SITE SUPPLEMENTAL INSTRUCTION

PROJECT: Forestside Estates
Attmar & Palleschi Drive
Brampton, Ontario

SITE SI NO. E-6

PURPOSE: Revised as per Arch SI A01 and Mech S SI M-2.

KEY NOTES	
	CONDENSING UNIT FED FROM STACKED HOUSE SUITE PANEL REFER TO MECHANICAL DRAWINGS FOR EXACT LOCATION AND QUANTITY
	WEATHER-PROOF PEDESTAL MOUNTED RECEPTACLES

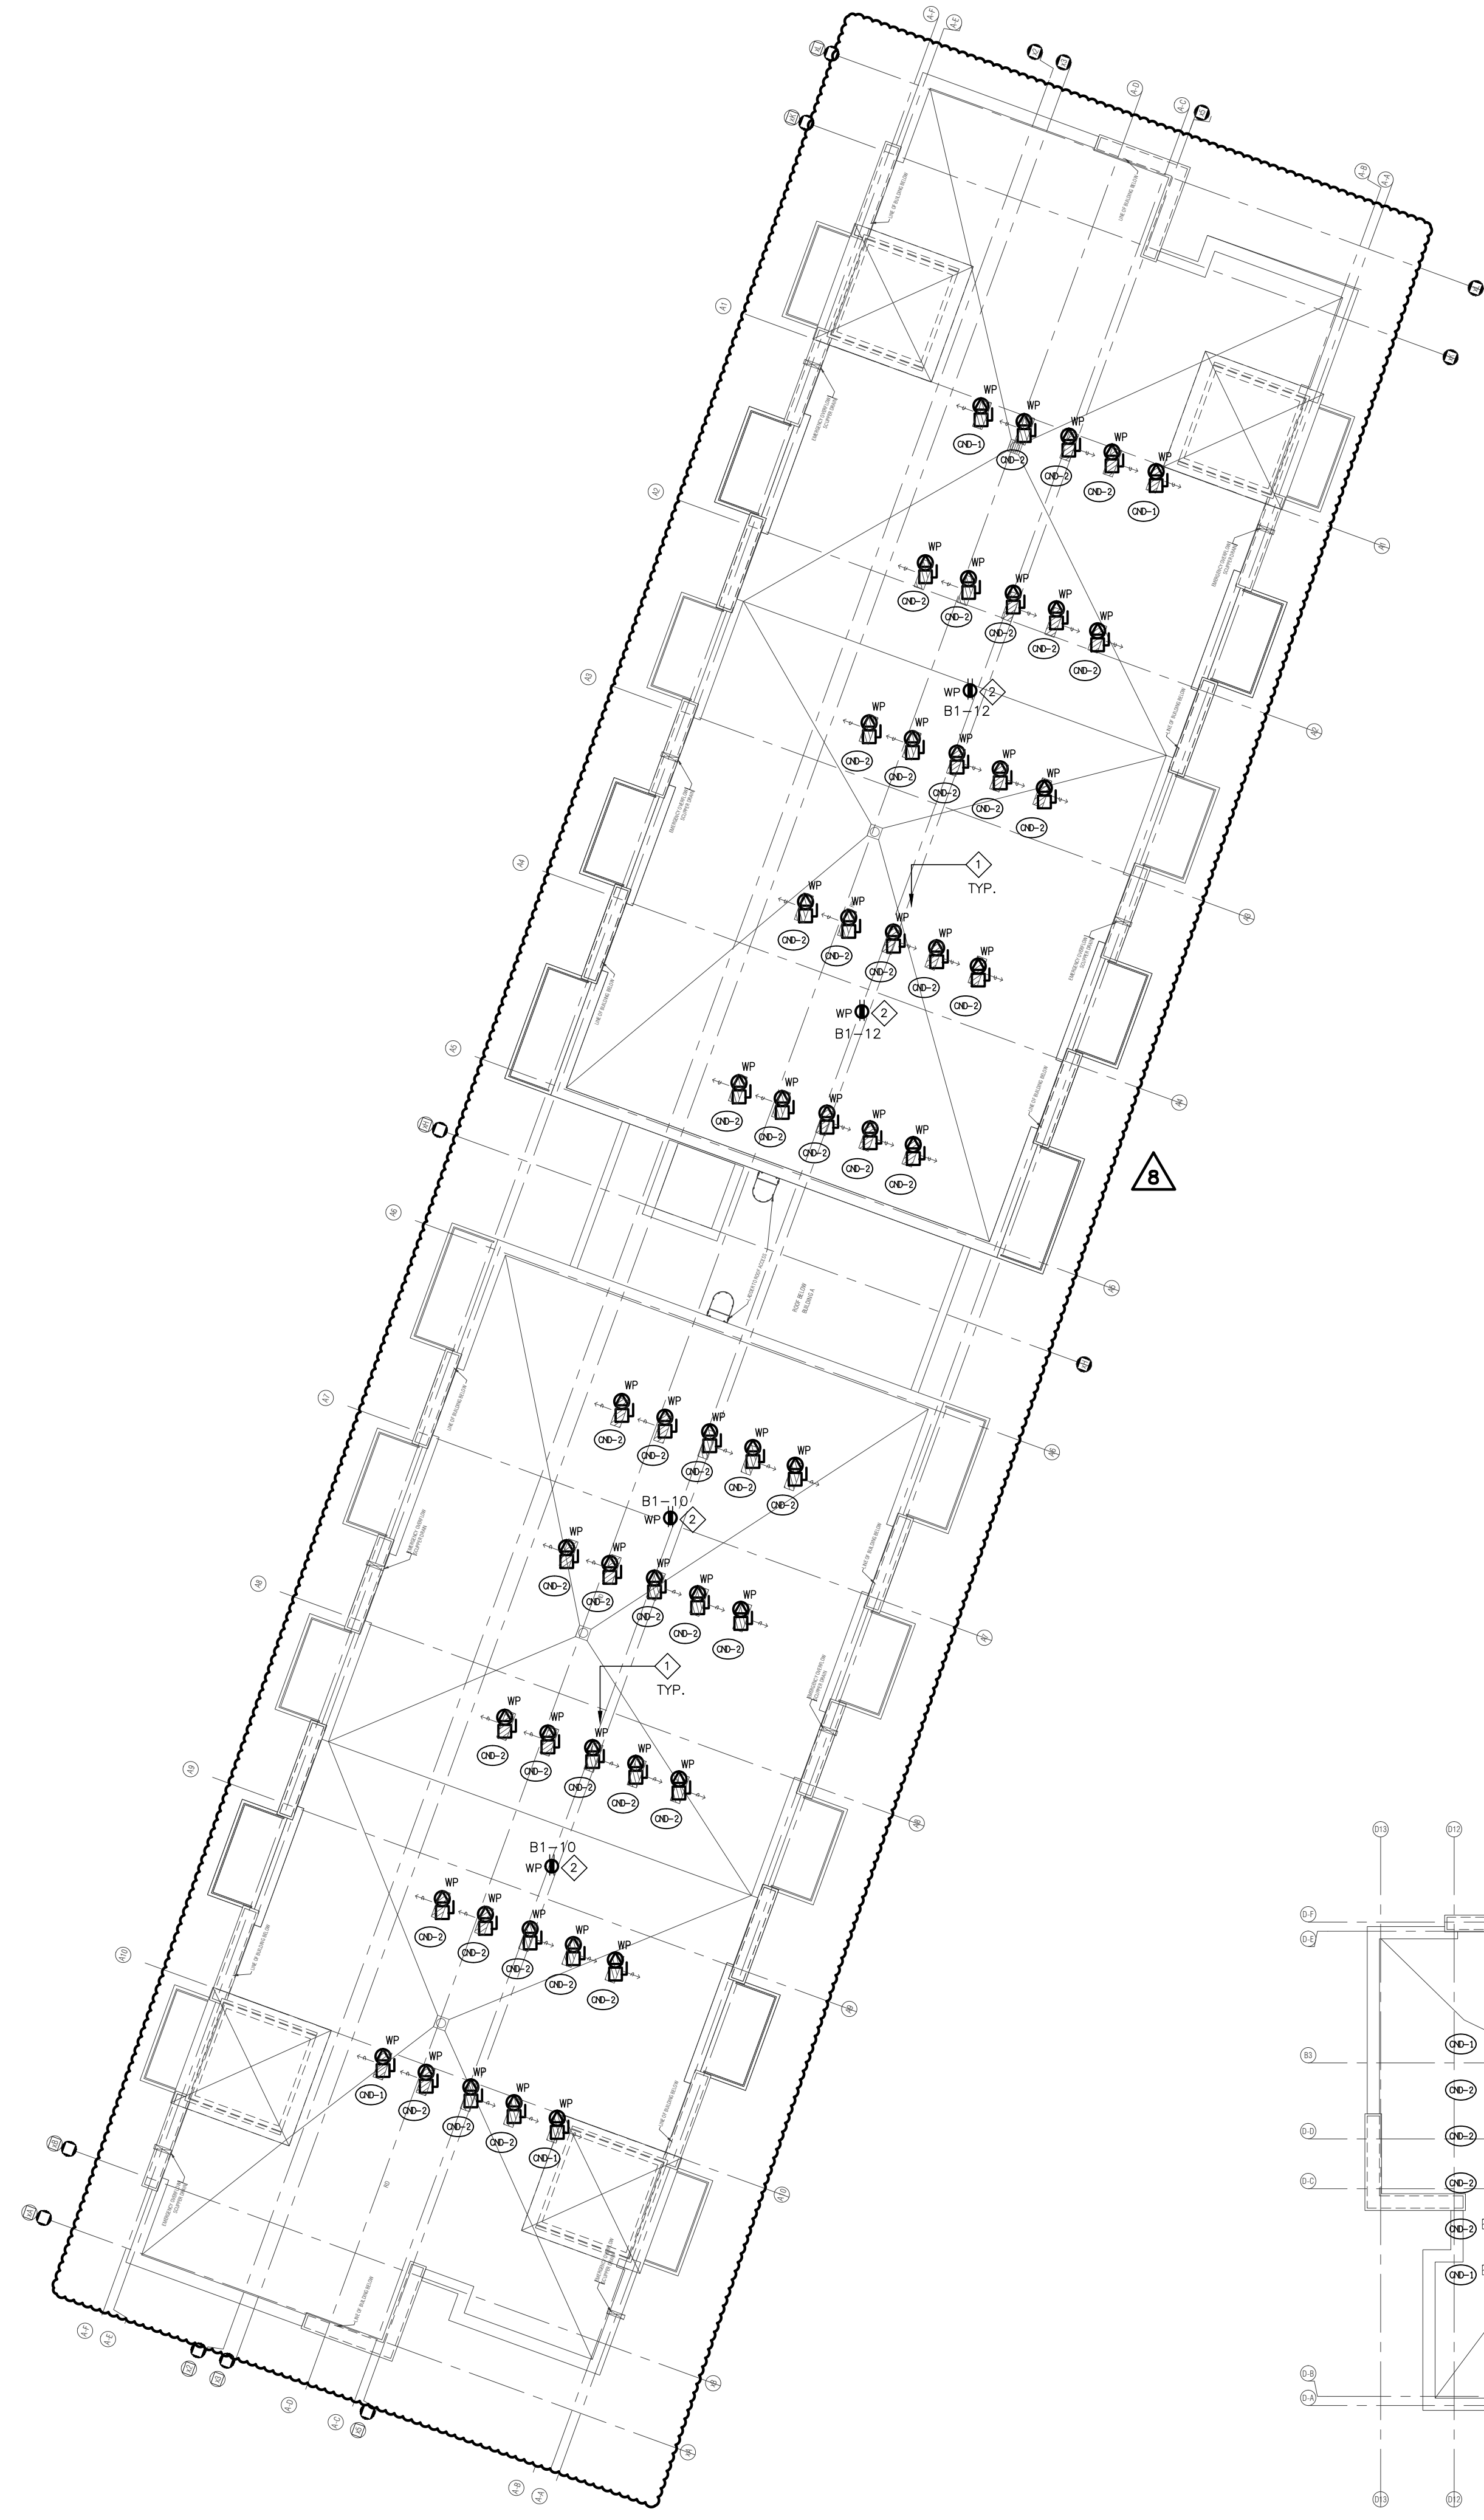
3.0 Reference Drawings E-7 (Roof -Electrical) Issued

3.1 Add: Condensing units for building D as shown.
